E7515A-01A

Modification Recommended Service Note

E7515A UXM Wireless Test Set

Modify The Embedded PC To Improve Boot Reliability

Figure 1

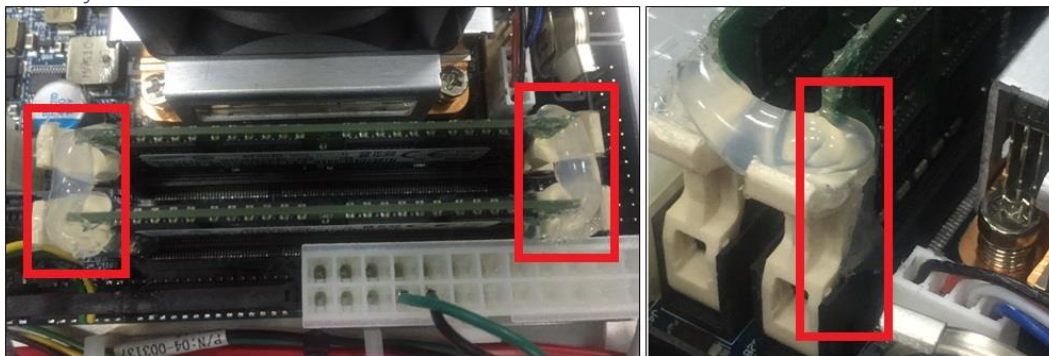
The E7515A will fail to boot if either of the RAM modules on the Embedded PC is not fully engaged in the memory slot.

Remove the outer covers from the instrument and inspect the RAM modules on the Embedded PC. If the RAM modules have been secured with thermal glue (as shown in Figure 1), then this service note does not apply – the modification has already been implemented.

Take note that the glue must be applied along the full length of all 4 latches, securing them to the RAM sockets (as shown in the right-side of Figure 1). This is the revised design change that further improves reliability.

Carefully apply thermal glue as indicated in Figure 1. Wait for the glue to harden before re-assembling the instrument.

Figure 2

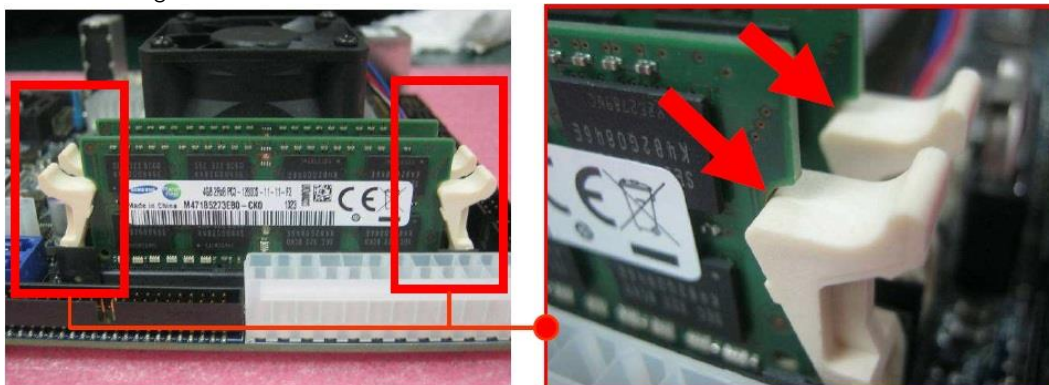
If the RAM modules have not been secured with glue, or if the glue is present but does not secure the latches to the RAM sockets, then ensure they are both fully engaged and locked in their memory slots (as shown in Figure 2).
